Item Name: Crosstube Turning Detail

DART AEROSPACE LTD		Work Order: 132267
Description: Crosstube Assembly		Part Number: D407-667-145
Inspection Dwg: D407-667-145 Rev: C		Page 1 of 2

DRAWING NO. D407-667-145	TITLE CROSSTUBE ASS'Y (407 HIGH FWD)	REV. C	DART AEROSPACE LTD ENGINEERING ORDER		D.E.O. NO. D407-667-145-C-1	SHEET NO. SHEET 1 OF 1	SCALE NTS
DRAWN 92	CHECKED ASS	MFG. APPR. AB	APPROVED WD		DE APPR. H		
DATE 11.07.15	DATE 11.07.22	DATE 11.07.22	DATE 11/07/22		DATE 11.07.21

DRAWING NO. D407-667-145	TITLE CROSSTUBE ASS'Y (407 HIGH FWD)	REV. C	DART AEROSPACE LTD ENGINEERING ORDER	D.E.O. NO. D407-667-145-C-2	SHEET NO. SHEET 1 OF 1	SCALE NTS
DRAWN AJS	CHECKED	MFG. APPR. <i>E</i>	APPROVED <i>AD</i>	DE APPR. <i>AD</i>		
DATE 12.08.02	DATE 12.08.02	DATE 12.08.02	DATE 12.08.02	DATE 12.08.02	DATE 12.08.02

DETAIL P
BONDING STRAP INSTALLATION 2 PL

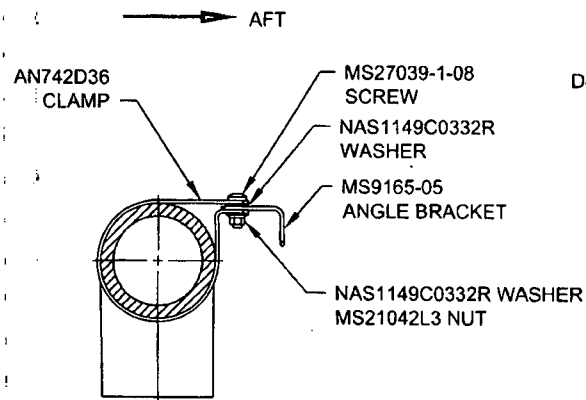
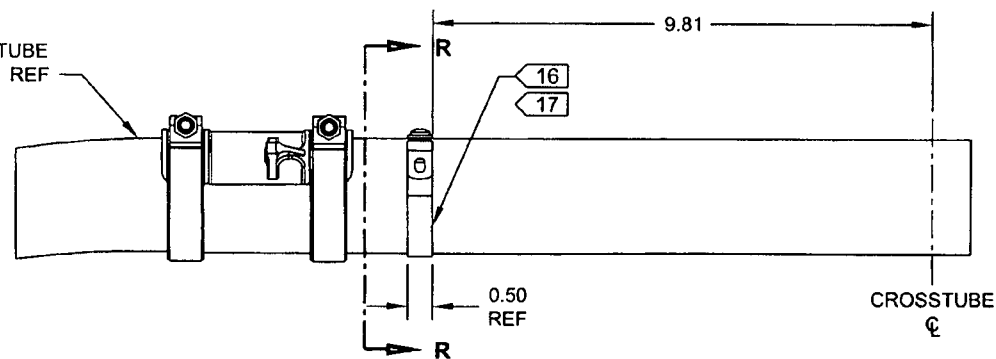
PURPOSE:

ADD ELECTRICAL GROUNDING STRAP

CHANGE:

ITEM	QTY -145	PART NUMBER	DESCRIPTION
1	X	D407-667-145	CROSSTUBE ASSEMBLY (407 HIGH FWD)
10	2	AN742D36	CLAMP
11	2	MS9165-05	ANGLE BRACKET
12	2	MS21042L3	NUT (OR MS21042-3)
13	2	MS27039-1-08	SCREW
14	4	NAS1149C0332R	WASHER (OR AN960C10L)

ADD

- 16) MASK AREA UNDER CLAMP PRIOR TO PAINTING
- 17) SEAL EDGES WHERE AN742D36 CLAMP MEETS WITH THE CROSSTUBE USING SIKAFLEX-241/-291 OR MIL-S-8802 CLASS B2 OR PROSEAL 890 SEALANT
- 18) PERFORM RESISTANCE CHECK TO ENSURE MAX RESISTANCE IS 10 MILLIOHMS
